Replacement Sheet

## Annotated Marked-Up Drawings

Fig.1

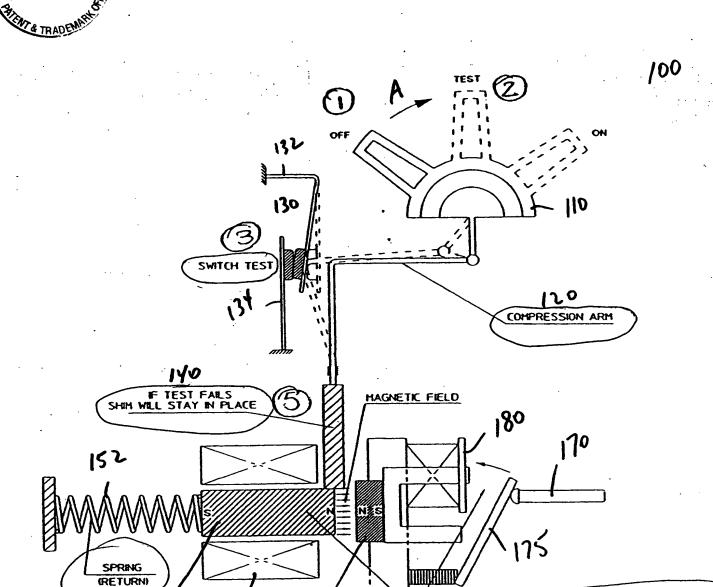
TE TEST FAILS (PROBLEM IN THE CIRCUIT) MAGNET IN PLACE WILL NOT ALLOW RELAY TO RESET OR CLOSE.
